UN Regulation No. 129 (Enhanced Child Restraint Systems)

Proposal for the 04 Series of Amendments to UN Regulation No. 129 (Enhanced Child Restraint Systems) *

Submitted by the expert from the Netherlands

The text reproduced below was prepared by the Ad Hoc Group on CRS, aiming to introduce definitions, requirements and a test procedure for lower tether anchorages. The modifications to the current text of the UN Regulation are marked in bold for new or strikethrough for deleted characters.

**Figure 3 (f)
Generic Lower Tether Bracket**

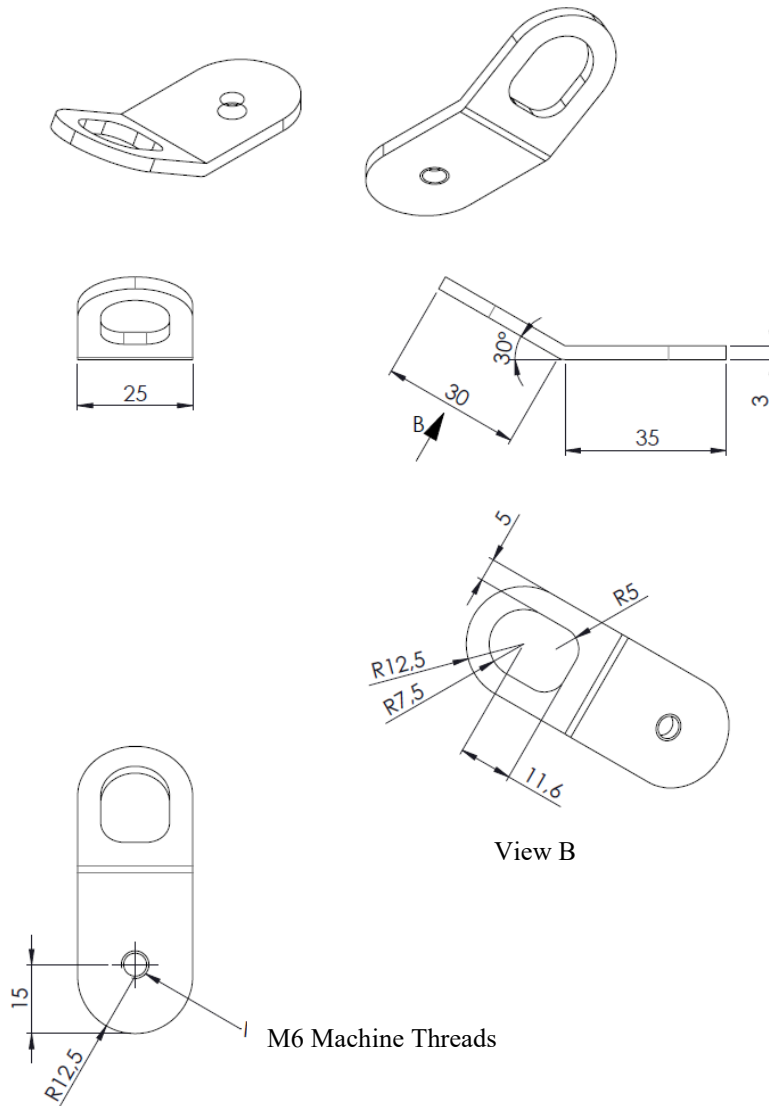
6.3.7.2. Dimensions and material specifications bracket:

- (a) The generic lower tether bracket shall have dimensions according to Figure 3 (f);
- (b) The outer edges of the lower tether bracket shall be at least blunted.

Figure 3 (g)
M6x8 Flange Buttonhead Hexagon Socketcap Screw (ISO 7380-2)

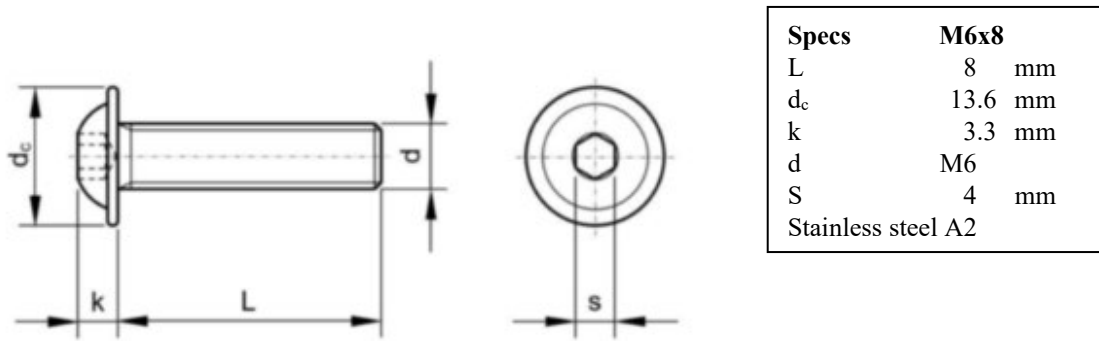
- (a) M6x8 flange buttonhead hexagon socket-cap screw see figure 3 (g);
- (b) M6 washer; see figure 3 (h);
- (c) M6 -8 shoulder washer; see figure 3 (i).

**Figure 3 (j)
Test 1**

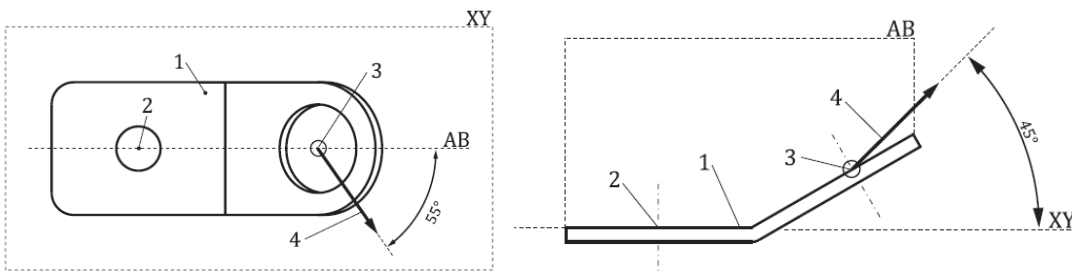
Two tests are performed; See figure 3 (j) and 3 (k)

- (a) the force shall be applied in a direction of $55^\circ \pm 5^\circ$ against plane AB, measured in a plane parallel to the rigid surface XY, and a direction of $45^\circ \pm 5^\circ$ against the rigid surface XY, measured in plane AB; see figure 3 (j);
- (b) the force shall be applied in a direction perpendicular ($90 \pm 5^\circ$) to the rigid surface XY.

Test Arrangement for a Rearward-Facing Device, Not Supported by the Dashboard

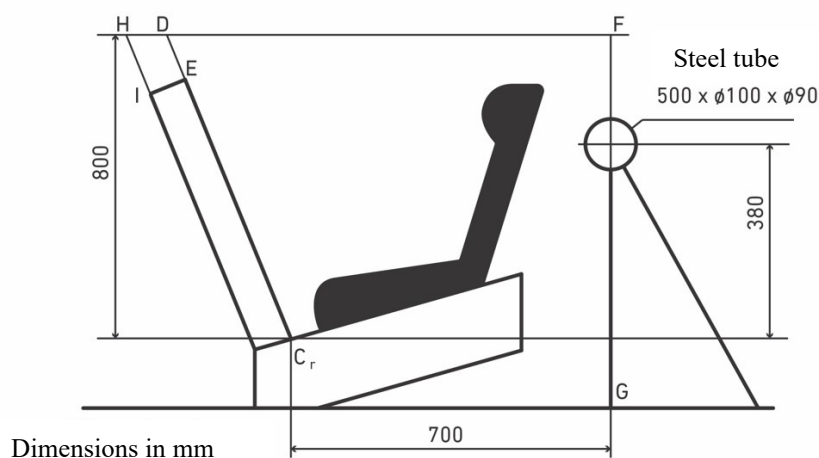
Where a test is conducted with paragraphs 6.6.4.1.6.1.1. or paragraph 6.6.4.1.6.1.2. or paragraph 6.6.4.1.8.2. above, only the second test results without 100 mm diameter bar will be considered. **A tolerance of +10 per cent shall be applicable to the head excursion value distance between Cr point and plane DF and the dummy should not pass beyond the plane HI, parallel to plane DE.**"

Figure 5, amend to read:

Arrangement and Use of Anchorages on the Test Trolley

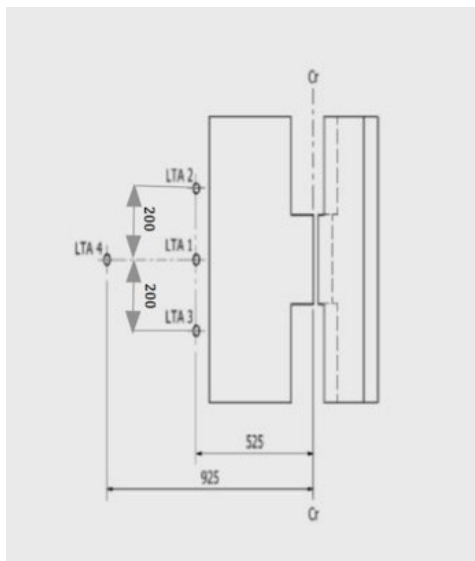
5. **For the testing of Enhanced Child Restraint Systems with lower tether(s), the floor shall be placed in its lowest position. LTA 4 is to be used in case the top tether anchorage from the seat in front is used. Otherwise LTA 2 and LTA 3; see figure 5. Generic lower tether brackets to be used for the dynamic test in case they are provided by the CRS manufacturer.**
